**UNITED STATES
NUCLEAR REGULATORY COMMISSION
ADVISORY COMMITTEE ON NUCLEAR WASTE AND MATERIALS
WASHINGTON, D.C. 20555-0001**

SUBJECT: WASTE PACKAGE AND DRIP SHIELD CORROSION, JUVENILE FAILURE OF WASTE PACKAGES, AND SPENT FUEL DISSOLUTION

ACNW&M Questions on Corrosion of the Waste Package and Spent Fuel Dissolution

WP Environment and Corrosion Modes

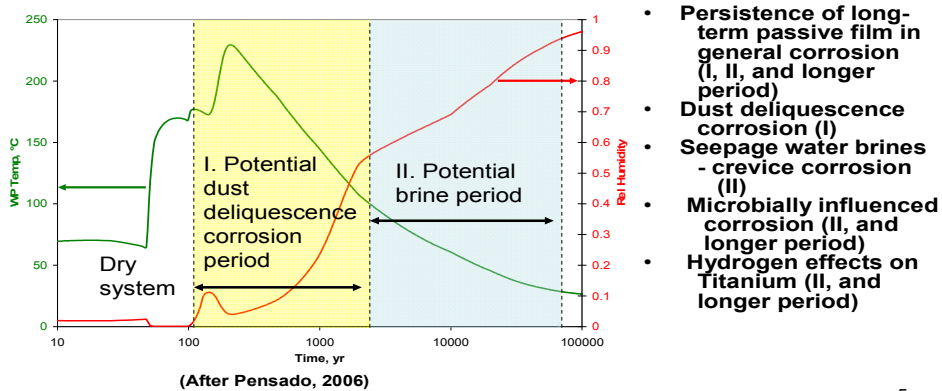
(Q5) What is the role of brine? What rate of water flow would be needed to get to the brine period?

The NRC has done much work on the formation of humidity deliquescence and corrosion induced by deliquescence on the waste package surface. The graph below shows two regions of potential corrosion, the dust deliquescence period and the brine period. However, a concentrated solution deliquescing on the surface (the dust deliquescence period) will have a high surface tension and thus only minimal contact with the surface, while a dilute solution (the brine period) that can spread over the surface will be minimally corrosive. It would appear that there would be little corrosion during either period.
